**TOWN OF BAY HARBOR ISLANDS
DEVELOPMENT & REVIEW COMMITTEE MEETING
THURSDAY, MARCH 9, 2023**

Subject: Site Development Plan Application – Revision - #2 DRC Review
9110 West Bay Harbor Drive - Multi-Family Residences (9 DU)
Bay Harbor Islands Acct. No.: SPR22-000032
MMPA Acct. No. 01-0702-1130C

**Town of Bay Harbor Islands
Development Review Committee (DRC) Staff Report - #2 DRC Review
9110 West Bay Harbor Drive - Multifamily Residential Development (9 DU)
Site Development Plan Application - Revision
March 3rd, 2023
Page 2**

1 FLOOR PLAN - LEVEL 1
SCALE: 1/8" = 1'-0"

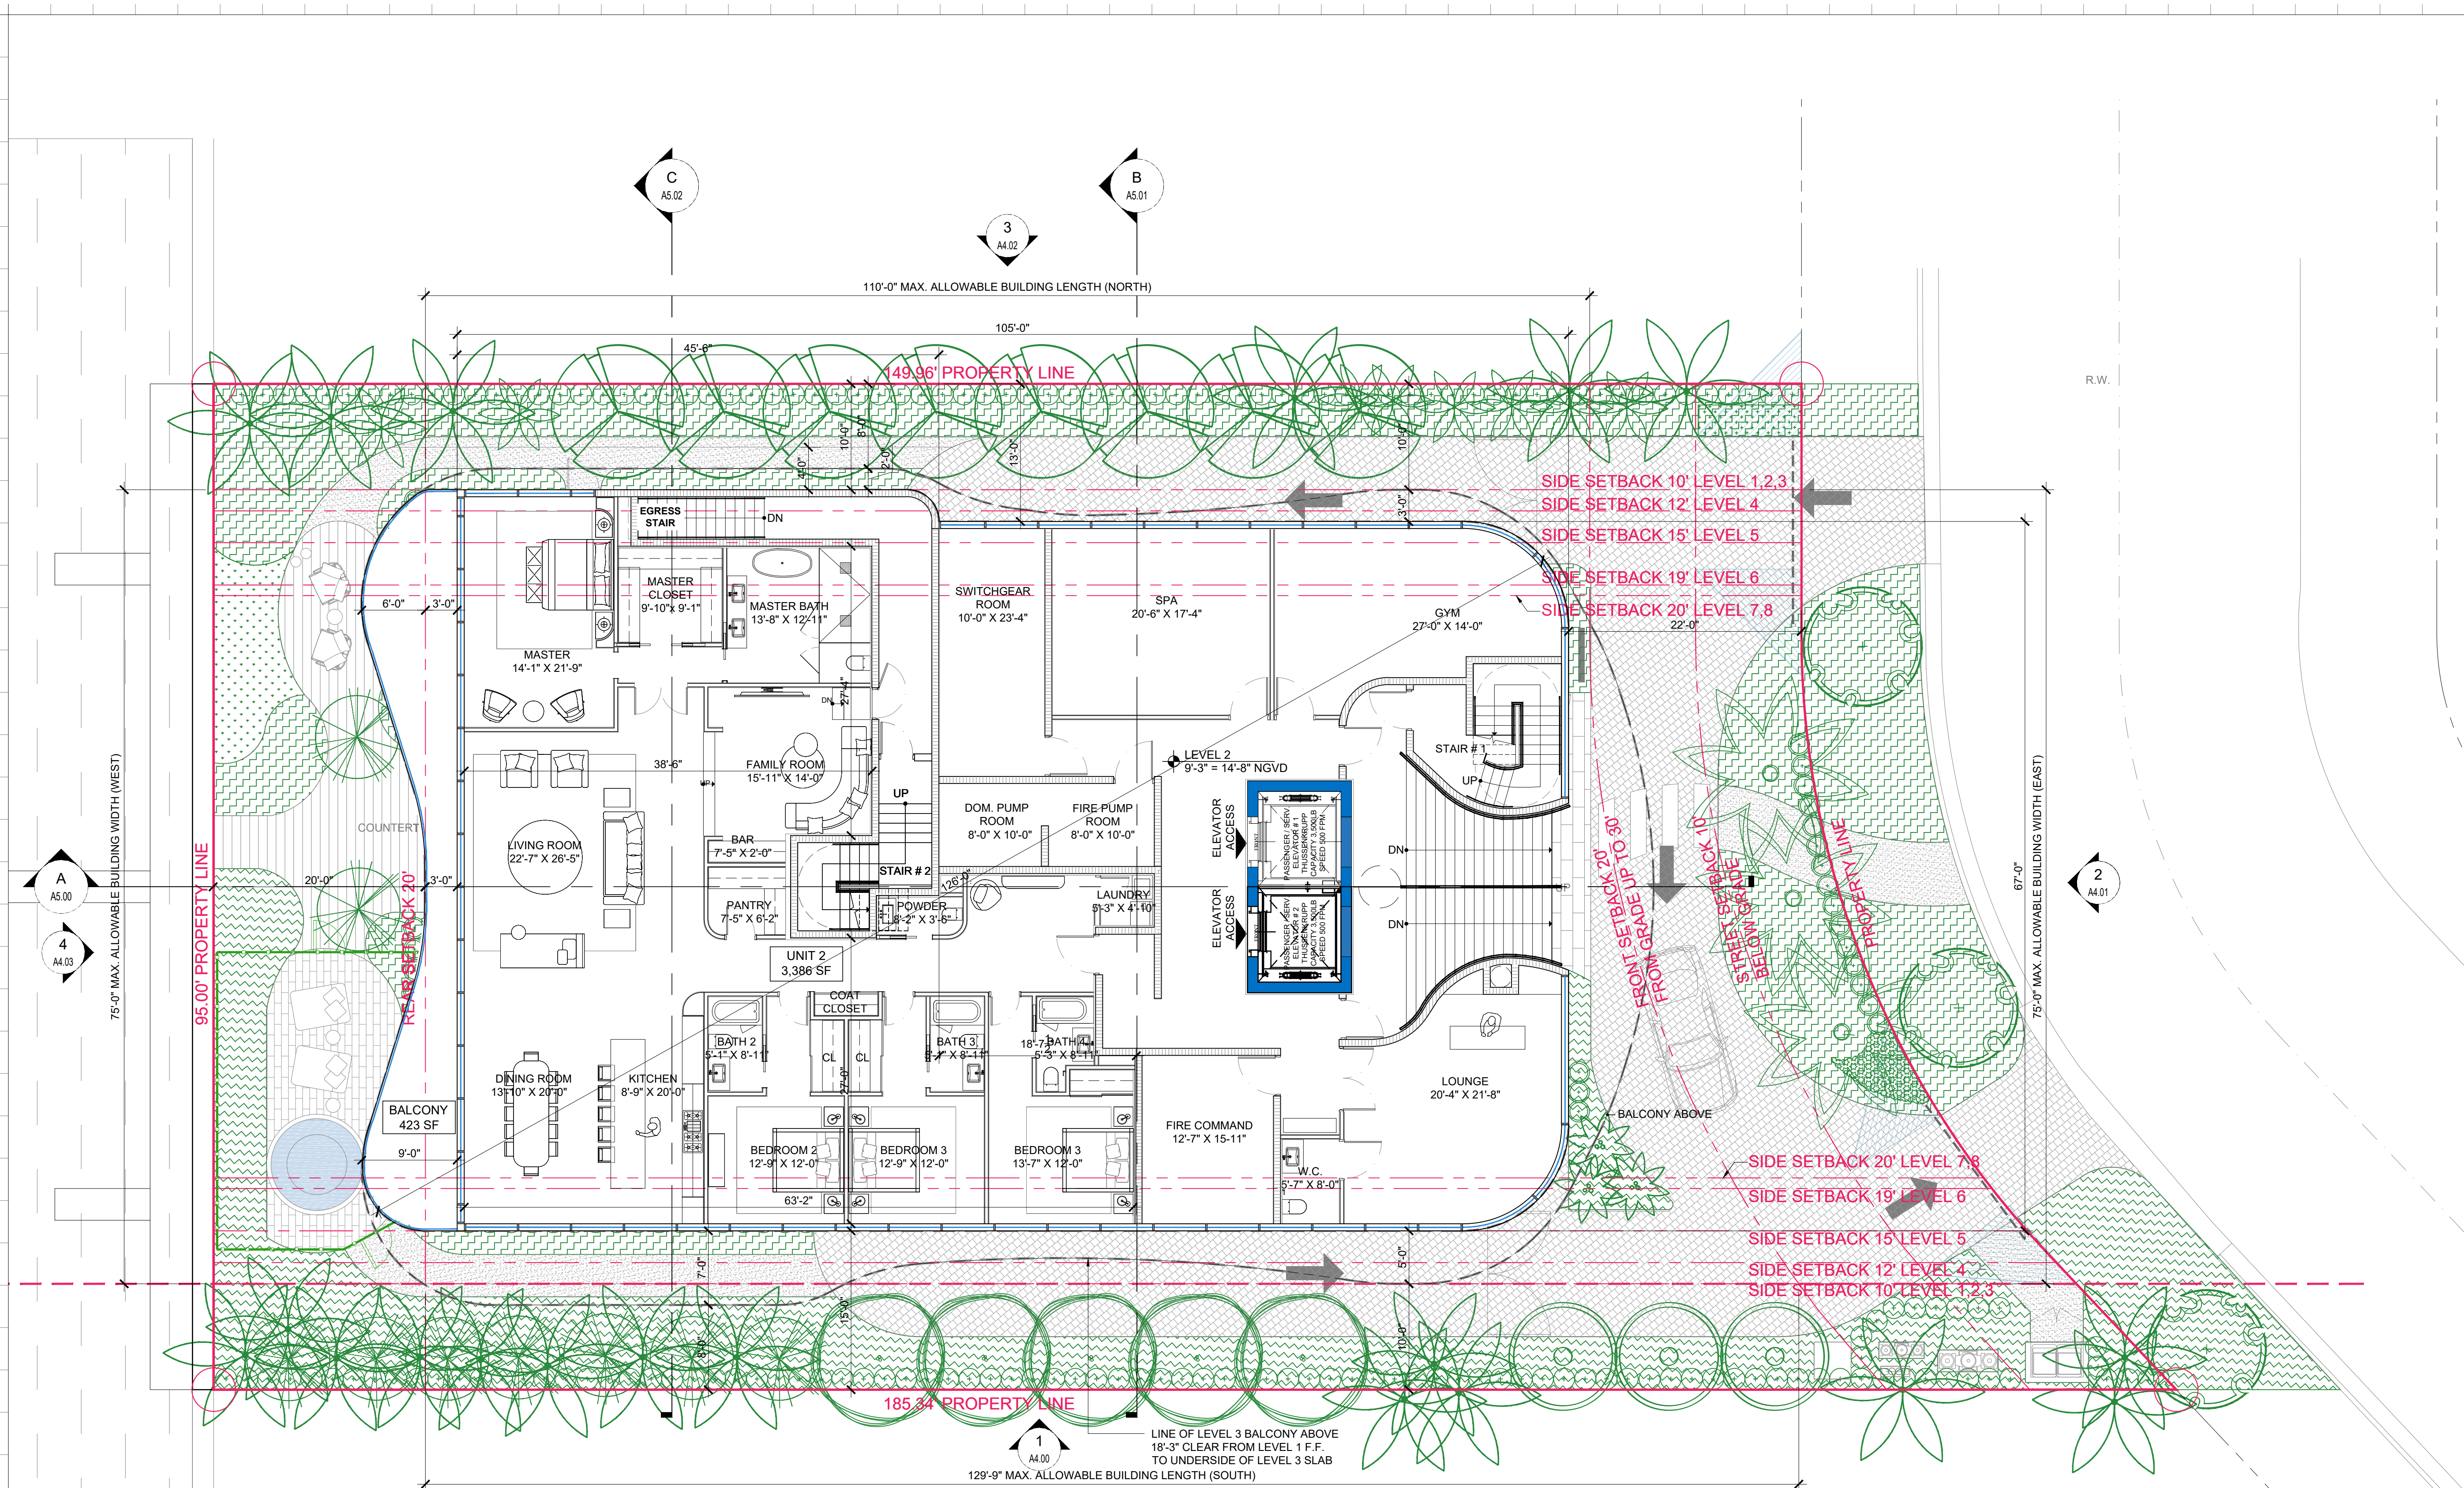
- 5) On Sheet A3.01 Unit 2a is listed as 3,368 square feet – it is also listed as 3,380 square feet on the same sheet. Please confirm – possibly a typo.
